Project **Marden SWDS**

Title **Section Through Lowest Site Elevation (Highest Flood Depth)**

Client **Origin Power Services**

Drawn: D Anderson	Designed: D Anderson
Checked: R Dobson	Approved: R Dobson
Project Reference: 2019s0929	Scale: As Shown @ A1
Drawing Number: IRA-JBAU-XX-XX-SK-C-0001	Status: S3 Revision: P01 Sheet Size: A1

TYPICAL SECTION A-A
1:100

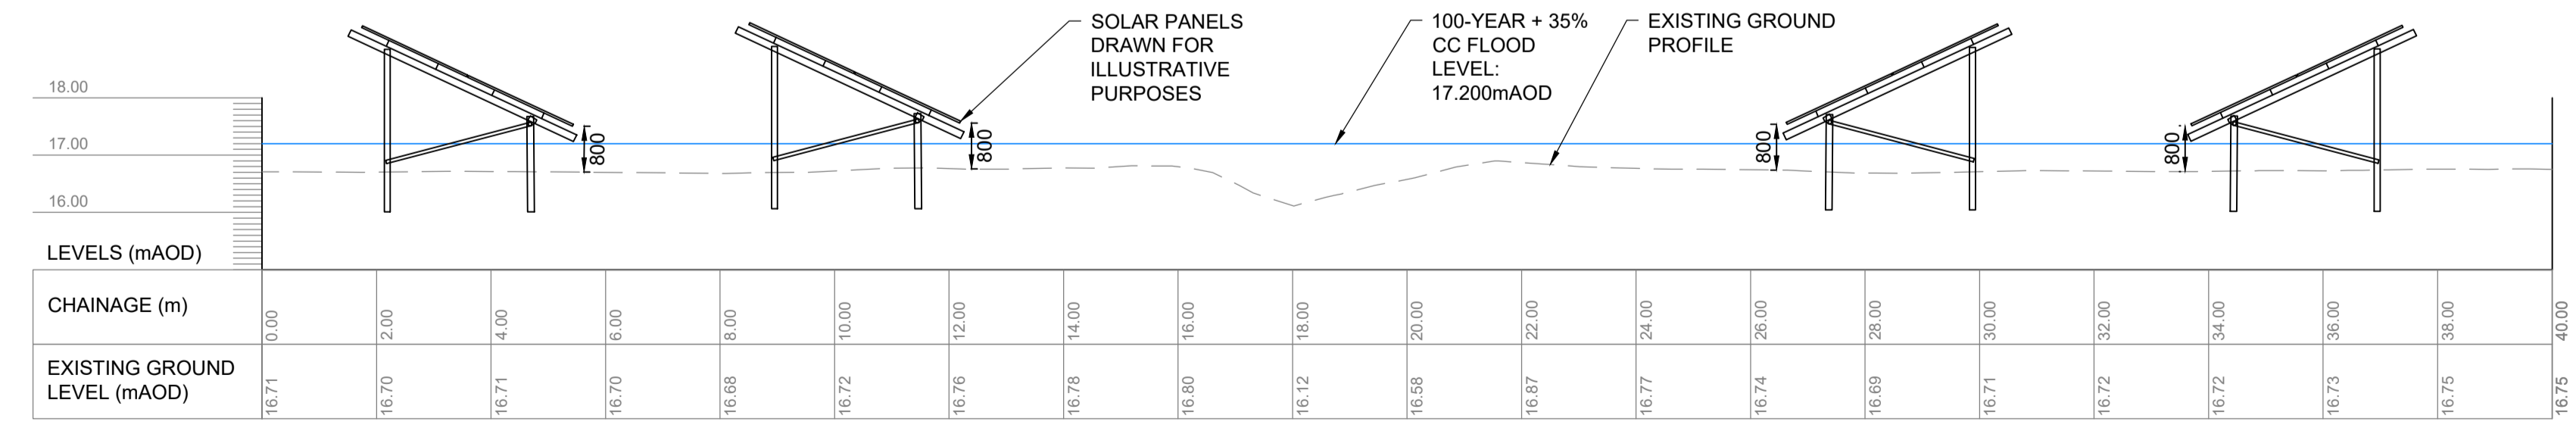
Addendum Statement
 This drawing illustrates a Typical Section A-A drawn at the lowest elevation within the site where solar panels would be present. As shown in Typical Section A-A, the design flood level does not exceed the base level of the solar panels which are set 800mm above existing ground level. To conclude, a design flood event will not affect any solar panels within the site and all solar panels will remain fully operational during a design flood event.
